design west | architects

date:	5.17.24
project:	Nibley Middle School
by:	Michael Rigby
subject:	Addendum 03

CONTRACT ADDENDUM 03

PLAN - LEVEL 01 - AREA E - SLAB & FOUNDATION

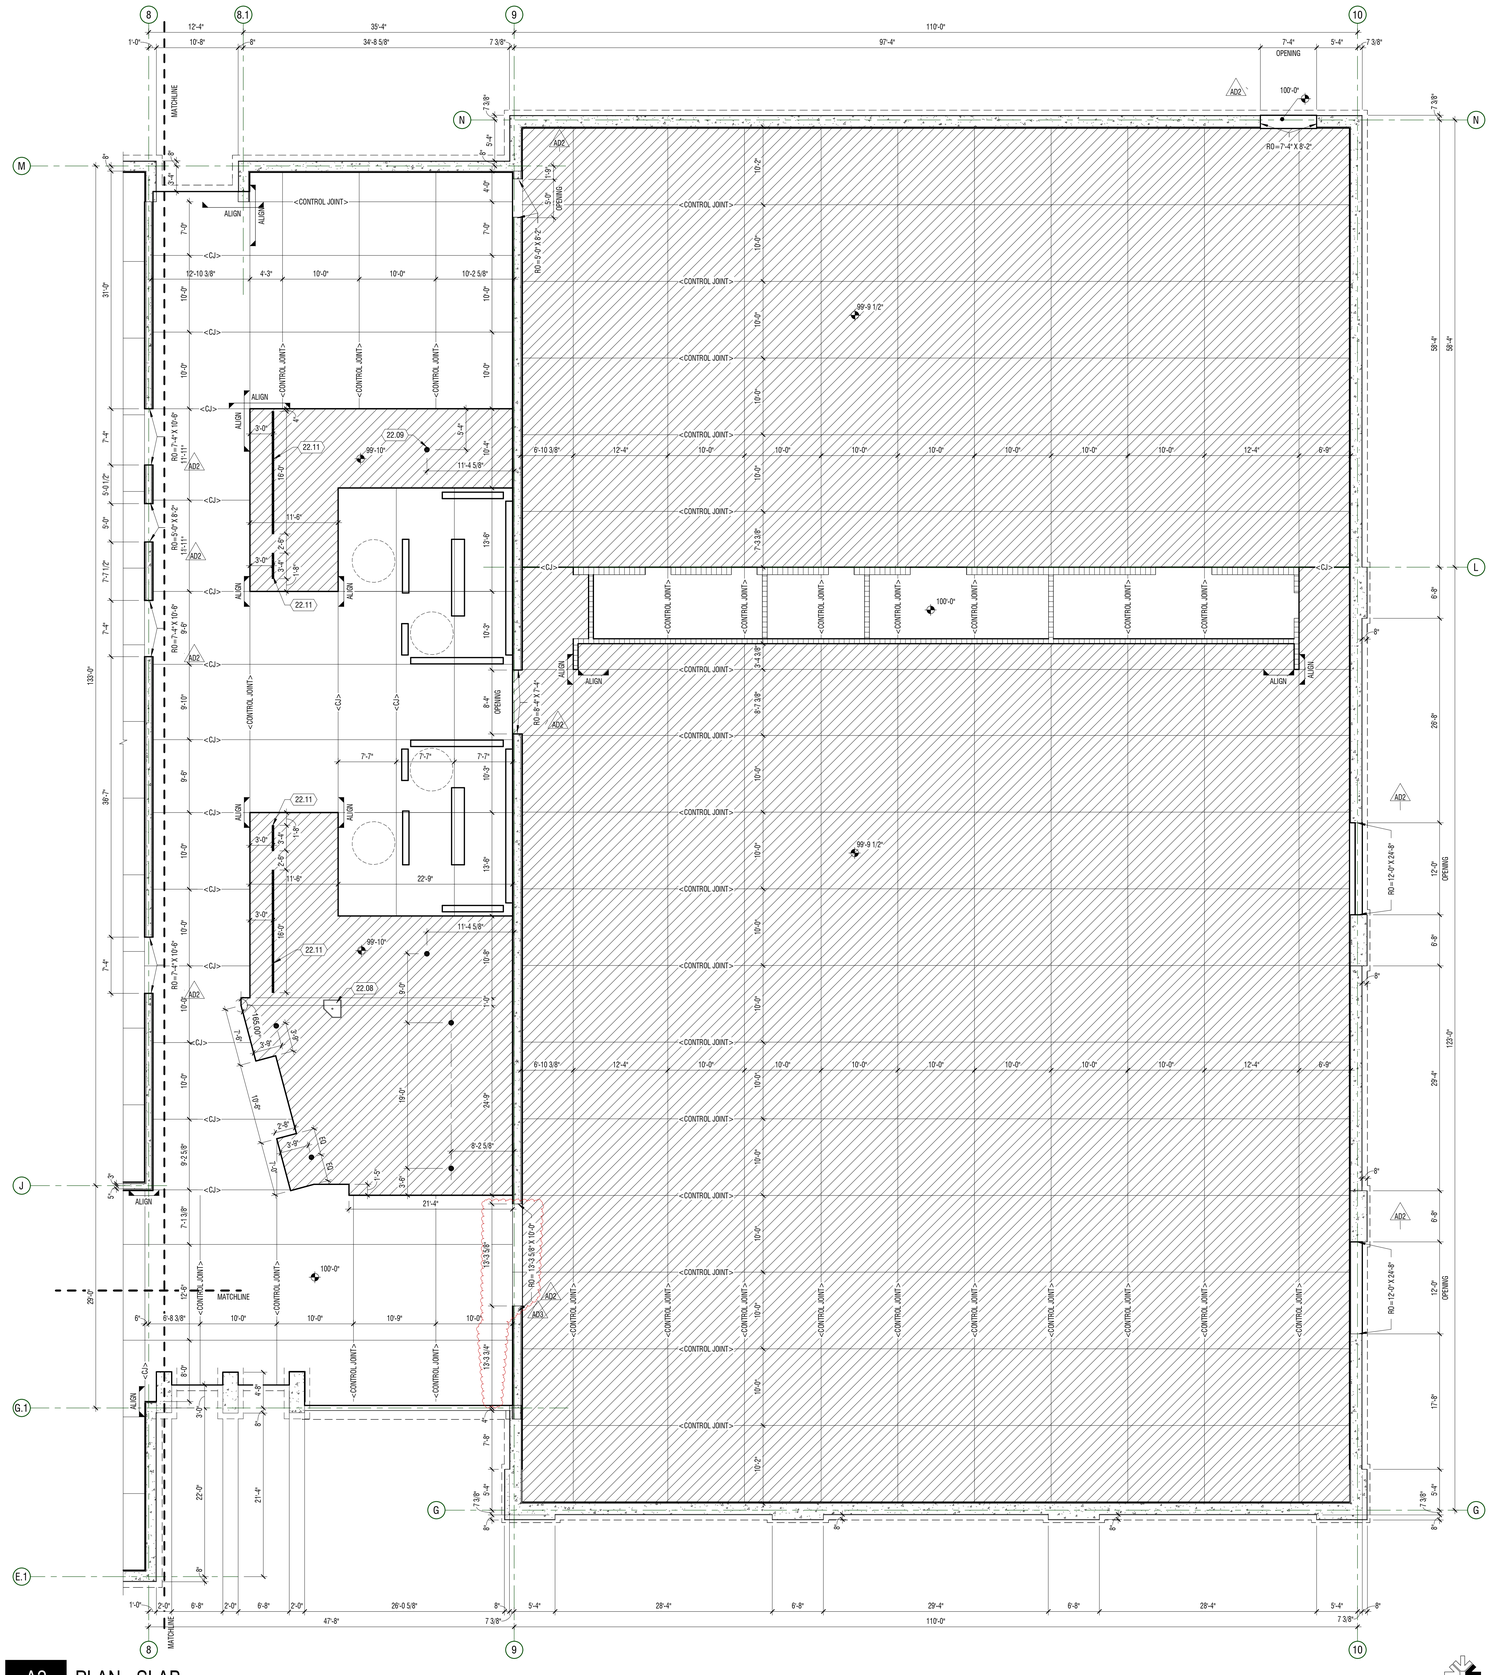
03.14 A-115.0 – PLAN – LEVEL 01 – AREA E – SLAB & FOUNDATION
- Rough Opening in ICF along grid H updated

PLAN - LEVEL 01
-AREA F - SLAB & FOUNDATION

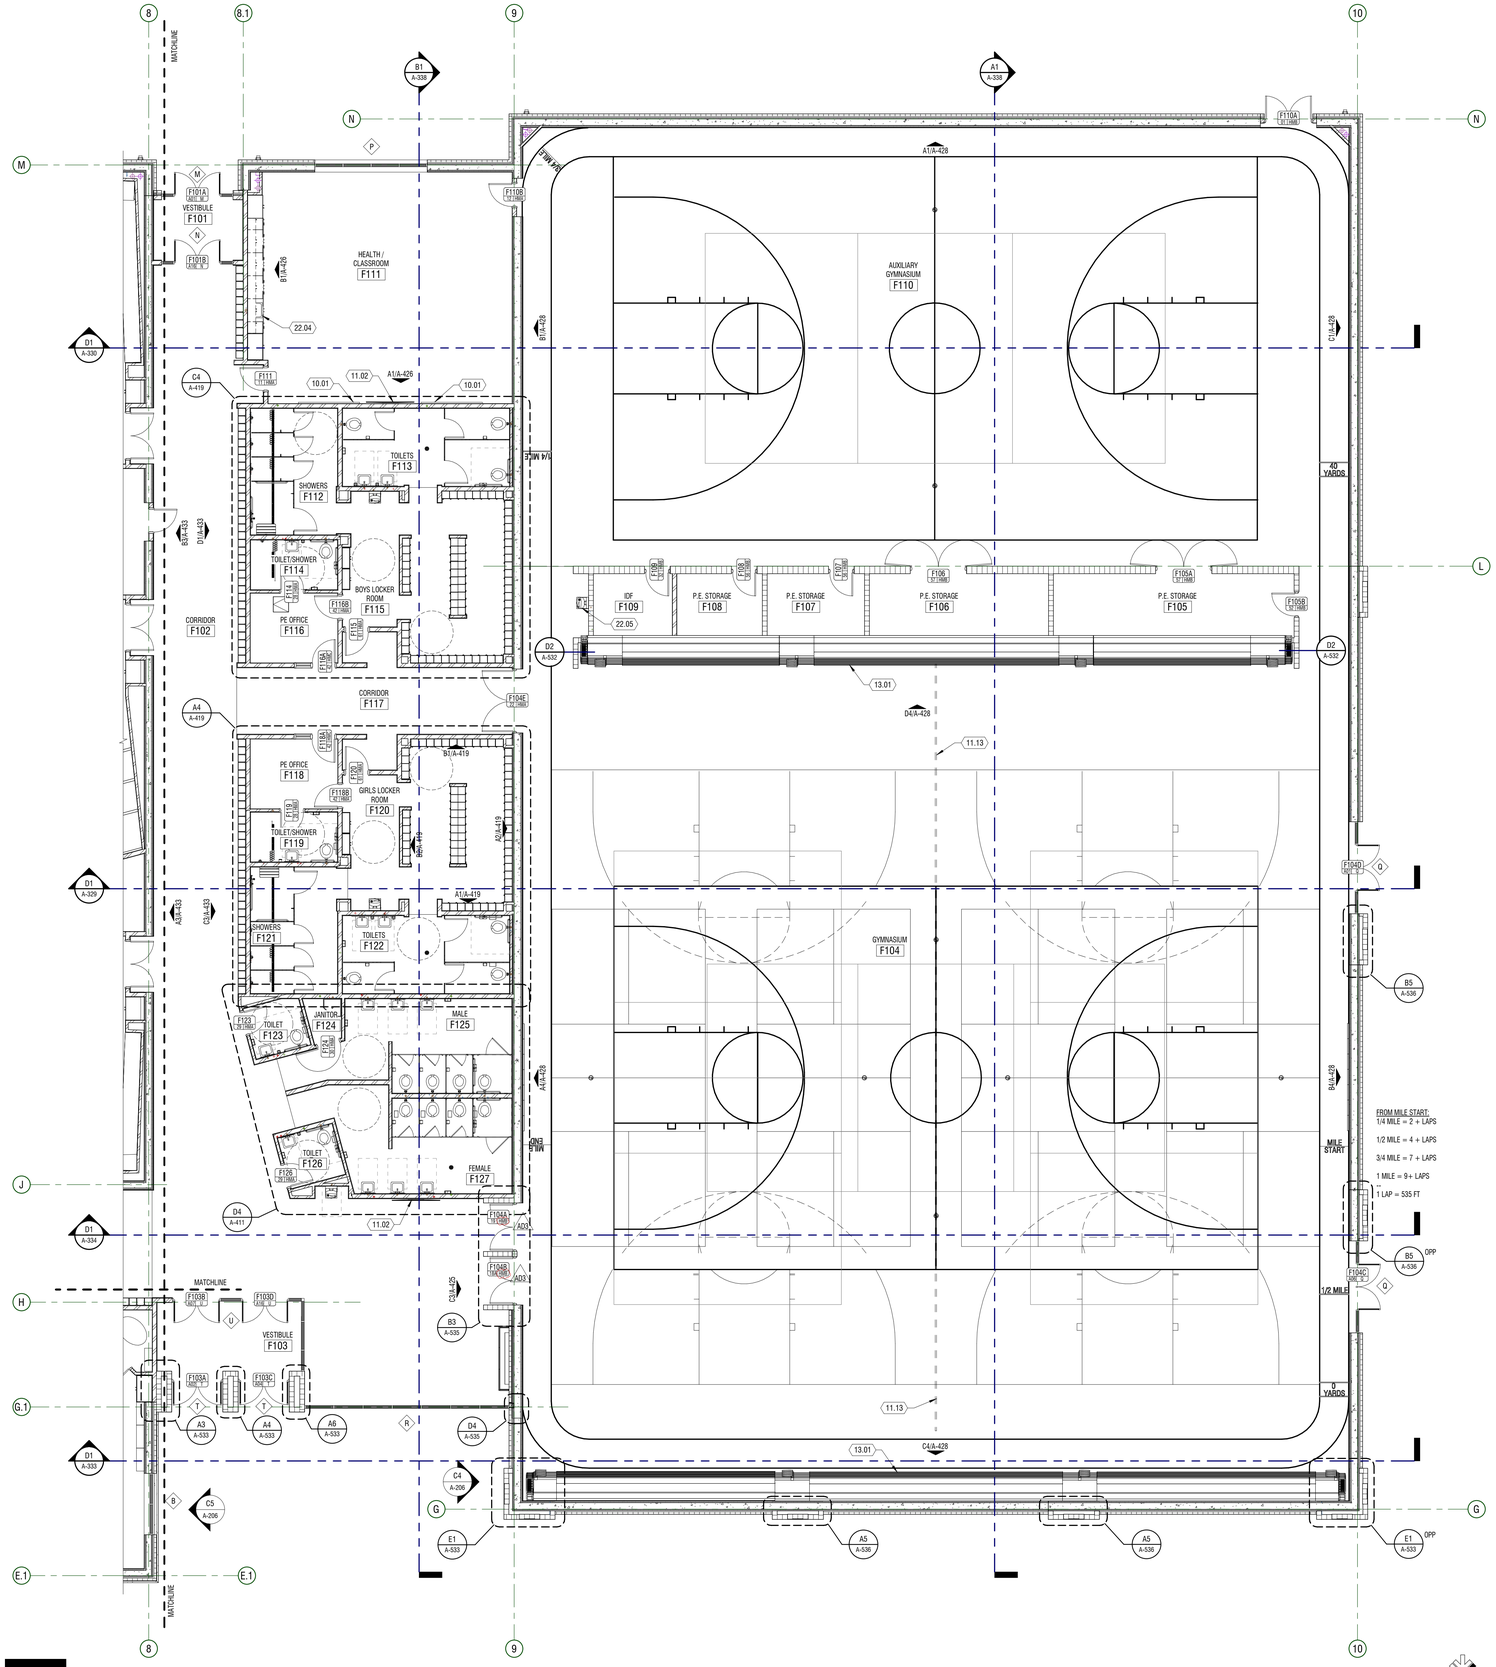
03.15 A-116.0 – PLAN – LEVEL 01 – AREA F – SLAB & FOUNDATION
- Rough Opening in ICF along grid 9 updated

PLAN - LEVEL 01 - AREA F - ANNOTATION

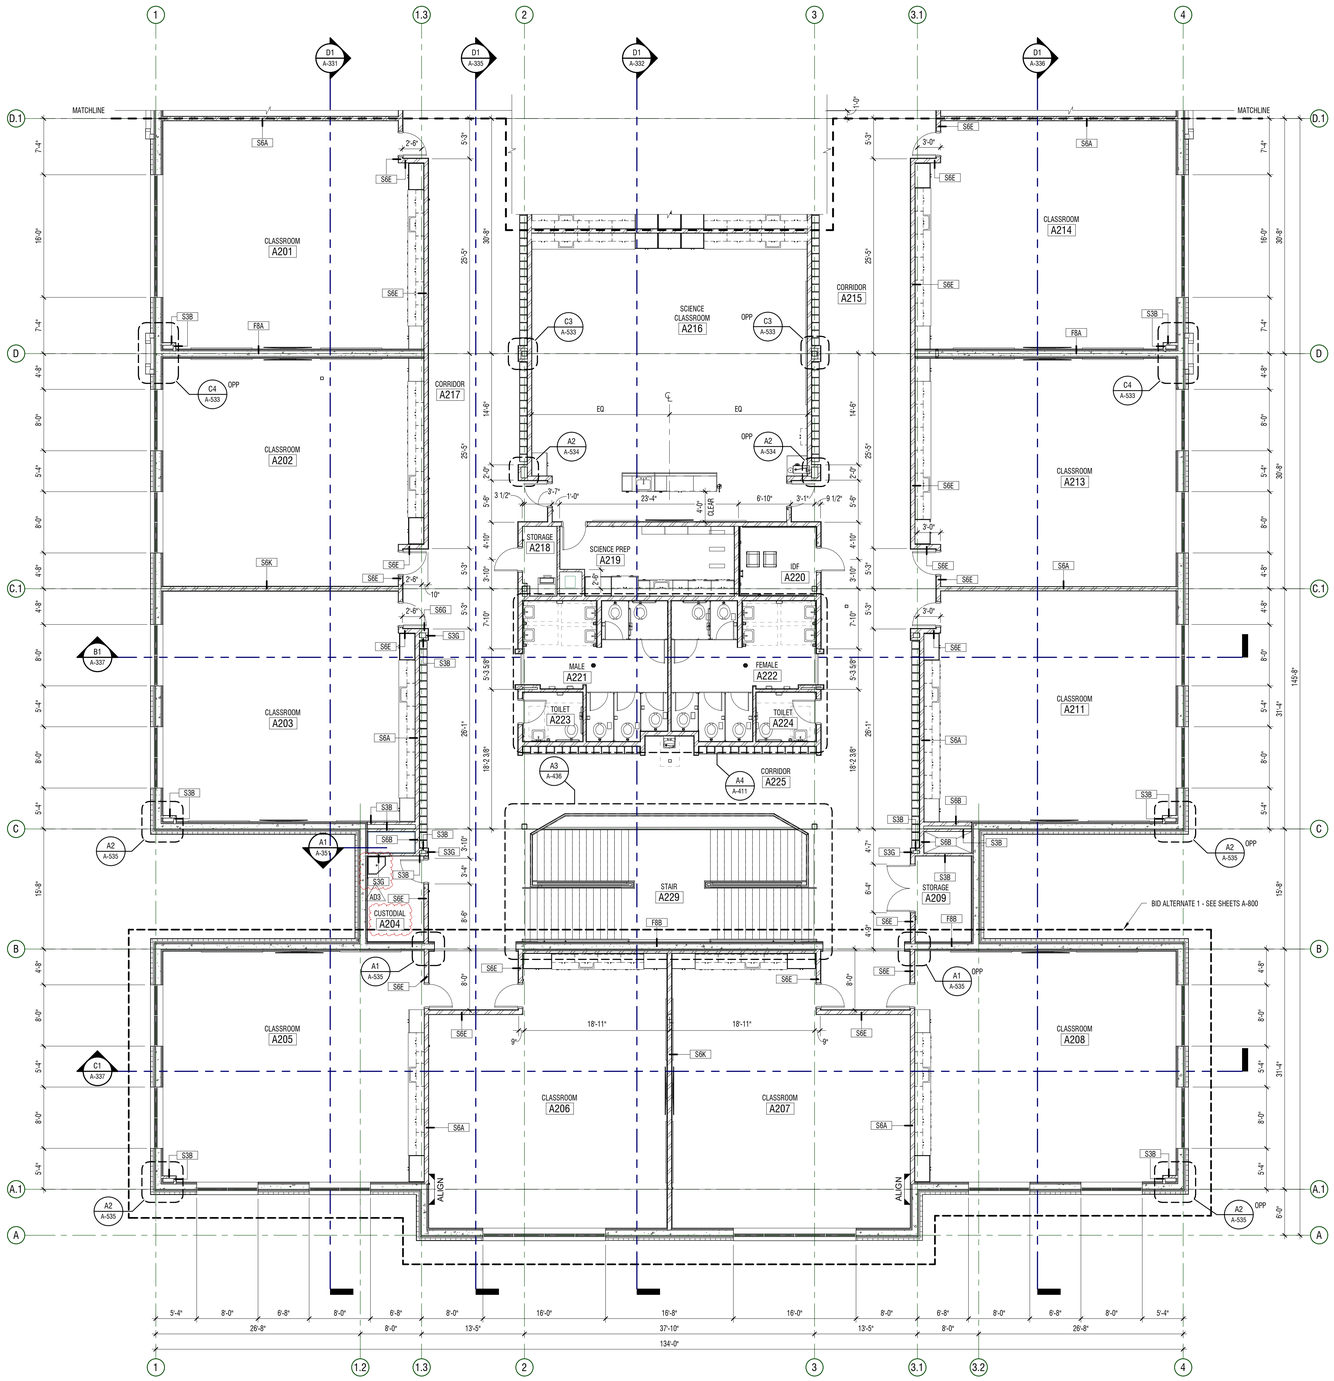
03.16 A-116.2 – PLAN – LEVEL 01 – AREA F - ANNOTATION
- Doors F104A and F104B frame types changed to HMB

M-111.F

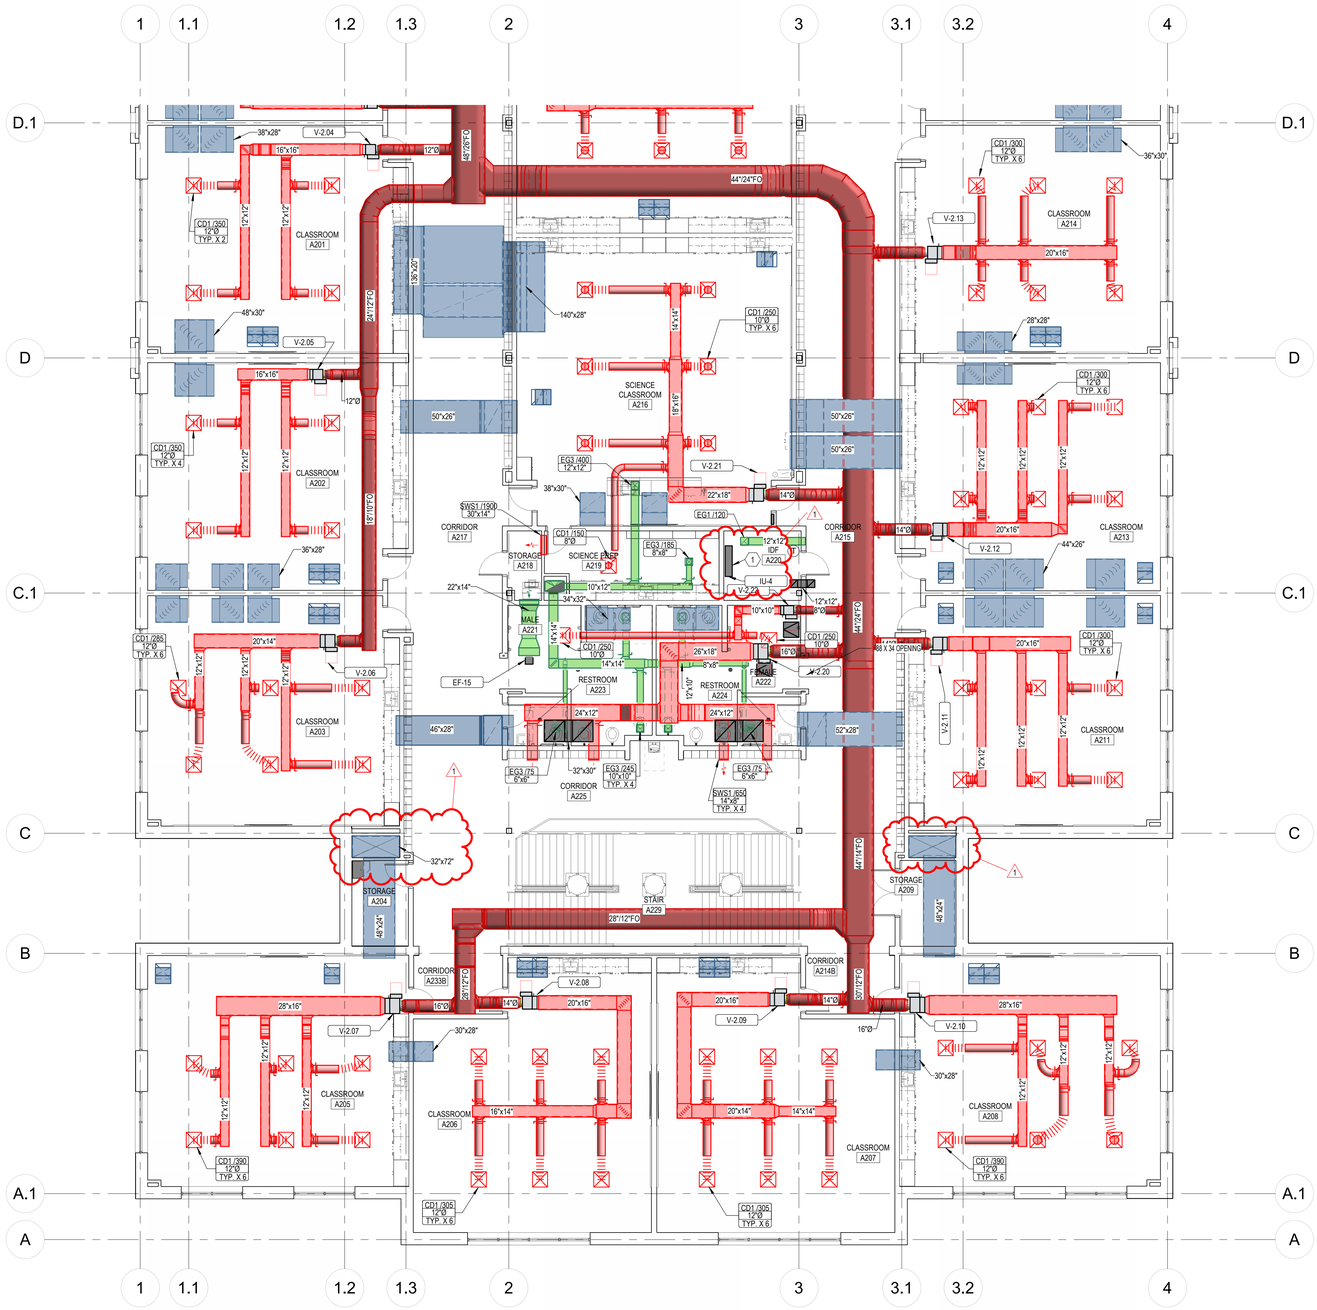
SHEET - M111.F
1. Add keyed note 1 as shown. See attached.

M-112.A

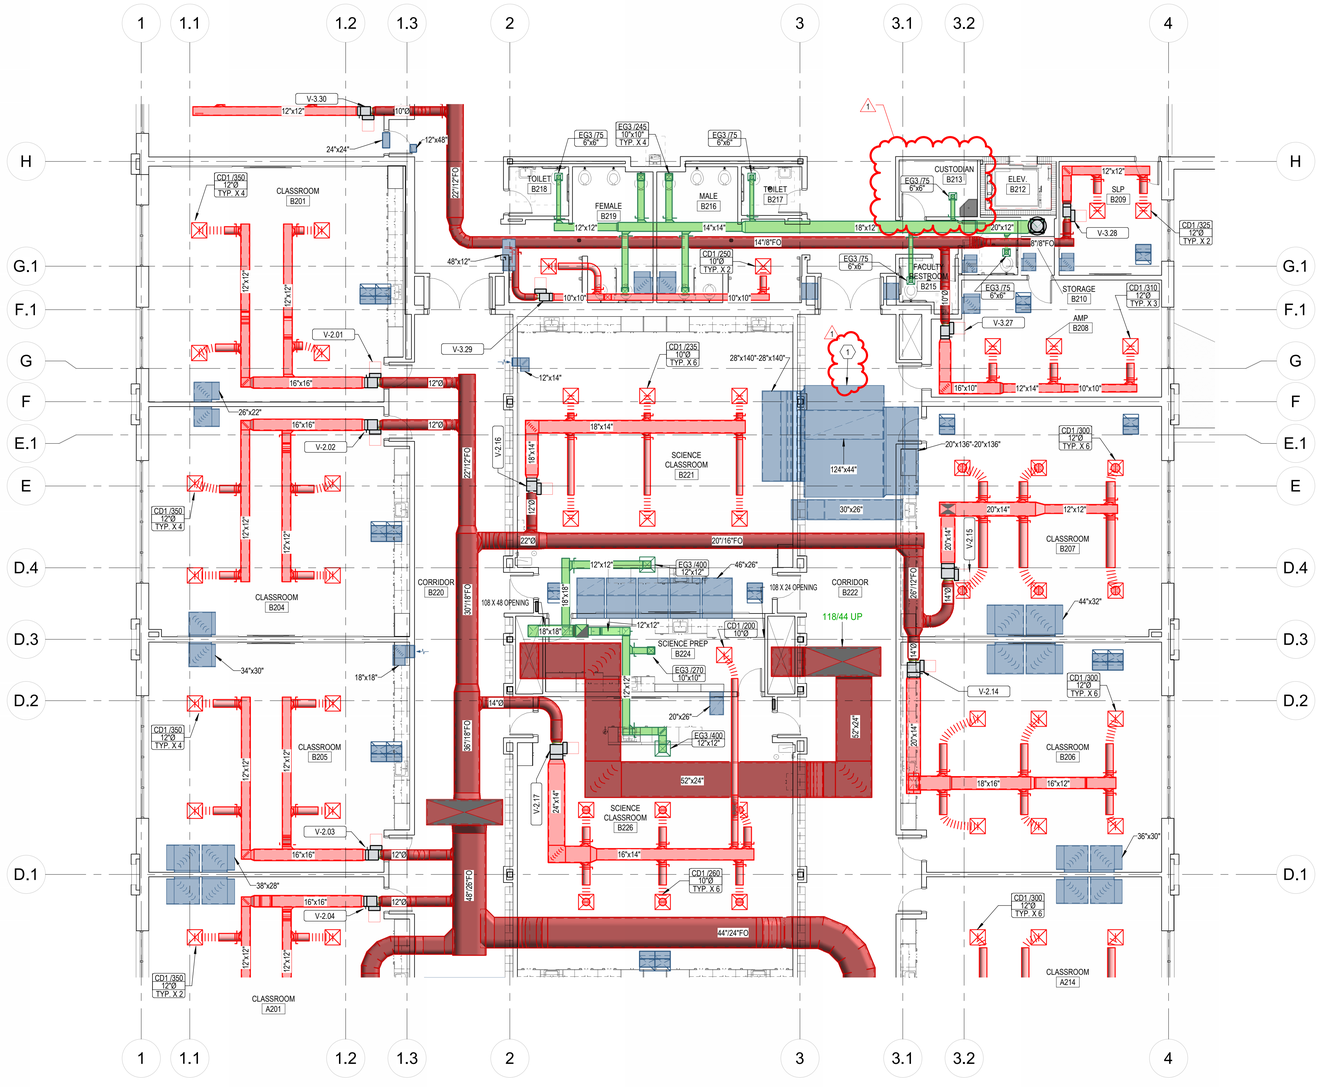
SHEET - M112.A
1. Add keyed note 1 as shown. See attached.
2. Modify duct riser in shaft as shown. See attached.
